# Planning and Zoning Board

Case Informatio	m
CASE NUMBER:	ZON18-00214
LOCATION/ADDRES	S: The 3100 to 3300 blocks of East Thomas Road (north side).
GENERAL VICINITY:	Located on the north side of Thomas Road and west of Val Vista Drive.
REQUEST:	Rezoning from AG and RS-43 to RM-2-PAD; and Site Plan Review, also consider the preliminary plat for "Lehi Cove"
PURPOSE:	This request will allow for the development of an attached single-residence development
COUNCIL DISTRICT:	District 1
OWNER:	Arthur L. Freeman Family Trust, Kaser Citrus, Inc., John Babiarz
APPLICANT:	Blake McKee, Skybridge Companies
STAFF PLANNER:	Evan Balmer, AICP
	SITE DATA
PARCEL NUMBER(S)	: 141-21-005P, 141-21-005R, 141-21-005Y and 141-21-005X
PARCEL SIZE:	7.5± acres
<b>EXISTING ZONING:</b>	AG and RS-43
<b>GENERAL PLAN DES</b>	IGNATION: Neighborhood: Suburban
CURRENT LAND USE	E: Vacant
	SITE CONTEXT
NORTH:	Loop 202 Red Mountain Freeway
EAST:	Vacant – Zoned GI
SOUTH:	Existing single residence – Zoned RS-9-PAD

The applicant is proposing an 89 unit attached single-residence development. The site is located on the north side of Thomas Road west of Val Vista Drive. The subject property consists of four parcels. One parce

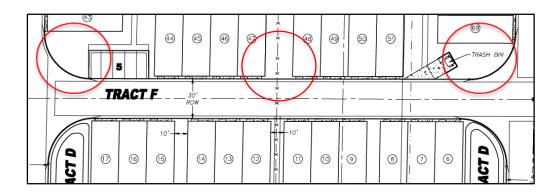
In order to create a more inviting experience and add some visual interest to the two internal alleys, staff would recommend adding a speed table and extending the landscaping along the pedestrian connections into the alleys between lots 32 and 33, lots 40 and 41, lots 64 and 65, and lots 74 and 75 as highlighted on the images below:

Another area that staff has concerns with is the internal pedestrian connection network. The applicant has included connections to the central amenity area from the east, west and north sides of the development, but there are still some areas of the development where the pedestrian connection is lacking. The southeast and southwest units specifically are only able to access the open space through the street network. Additionally, the parallel parking spaces on the perimeter of the development are lacking access to the sidewalk network. Staff would like to see some additional sidewalks added to provide a more robust pedestrian network. Some of the areas of concern are highlighted below.

- 1. Compliance with the basic development as shown on the site plan and preliminary plat submitted, except as modified below (without guarantee of lot yield, building count, lot coverage).
- 2. Compliance with all City development codes and regulations, except as modified in Table 1 of the staff report.
- 3. Compliance with all requirements of the Subdivision Technical Review Committee.
- 4. Prior to submitting for a building permit, submit a revised site plan for Planning Director review and acceptance that includes:
  - a. A reduction of the alley to a width of 24' and enhanced landscaping and speed tables between the following lots:
    - 32 and 33
    - 40 and 41
    - 64 and 65
    - 74 and 75
  - b. Enhanced pedestrian network from the central open space area to the following areas:
    - Southeast building
